# Access Compliance Report

## Public Rights-of-Way

### (Curb Ramps)

Intersection ID: 13518	Main Street: COMMONWEALTH_AV	Cross Street: ST_JULIEN_ST	Location: S
ADA ID: F27239969854	Ramp Type: Perp	Initial Pass/Fail: Pass	Overall Compliance: No
Codes/Mitigation Info/Possible Solution		Field Measurements/Component Compliance	
Severity Score: 7.5

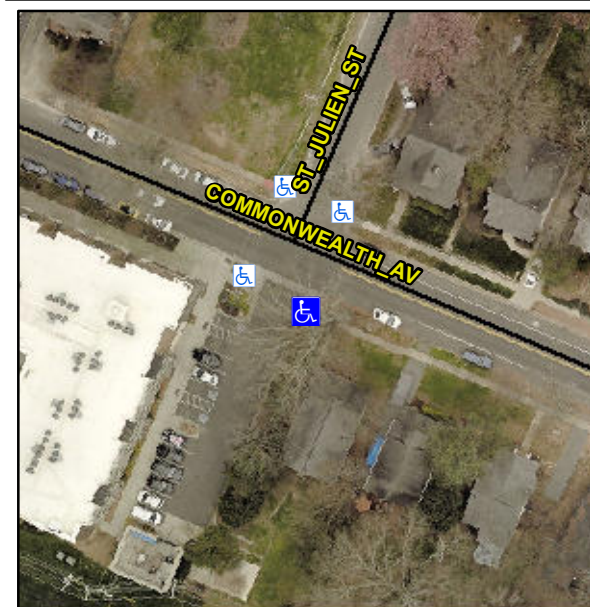
**Not Found, R304.2.1, R304.2.2-Perp,  
R304.3.2-Para, R305.1.4, R305.2,  
R304.5.4, R304.5.3**

Compliance	Description	Data	Compliance	Description	Data
N/A	Ramp Length (in)	62.0	Yes	Ramp Slope (%)	6.6
Yes	Ramp Width (in)	48.0	Yes	Ramp XSlope (%)	1.3
N/A	Flare Type LT	Sloped	N/A	Flare Type RT	N/A
N/A	Flare Slope LT (%)	9.0	N/A	Flare Slope RT (%)	11.4
N/A	Flare Traversable LT?	No	N/A	Flare Traversable RT?	No
No	Landing Length (in)	44.0	Yes	DWS Provided?	Yes
Yes	Landing Width (in)	48.0	Yes	DWS Contrast?	Yes
No	Landing Slope (%)	2.1	Yes	DWS Length (in)	24.0
Yes	Landing X Slope (%)	0.8	No	DWS Full Width?	No
N/A	Landing Curb? (Y/N)	No	No	DWS Offset (in)	5.5
N/A	Shared Landing?	No			
Yes	Gutter Ponding?	No	No	Gutter Slope (%)	5.6
Yes	Gutter Lip Ht (in)	0.0	No	Gutter X Slope (%)	3.8
N/A	Painted X Walk1?	No	N/A	Painted X Walk2?	N/A
	X Walk 1 Direction	To NW		X Walk 2 Direction	N/A
N/A	X Walk 1 Width (in)	N/A	N/A	X Walk 2 Width (in)	N/A
	X Walk 1 Slope (%)	3.4		X Walk 2 Slope (%)	N/A
	X Walk 1 X Slope (%)	2.6		X Walk 2 X Slope (%)	N/A

**Remove & Replace Entire Ramp.  
Remove & Replace Gutter.**
